To: Tim Clinkscales, PE Paramounte Engineering
From: Nicole Smith, Associate Planner; 910-341-1611
CC: File;
Date: 6/2/2020
Re: Crossroads Infiniti

■ **CROSSROADS INFINITI [TRC Plan Review #4]**

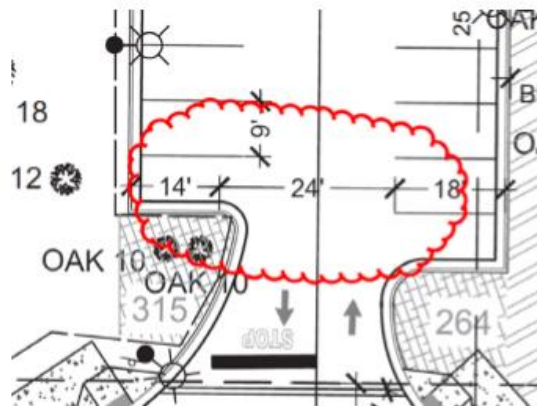
- 6) Sheet C-5.2 Pond Outlet Structure Detail Front View: Update orifice size.
- 7) Sheet C-5.2 Pond Emergency Spillway: Update label to “Emergency Spillway El.”
- 8) Sheet C-5.2 Vegetative Shelf Planting Section shows 6’ while Wet Pond Profile shows vegetative shelf as 8’. Please clarify.
- 9) Sheet C-4.0: Is there a profile and cross section for the proposed road improvements within the 50’ access easement? I see that the road has been stationed and want to make sure I am not missing sheets.
- 10) Provide SCM & Inlet Drainage Area Maps
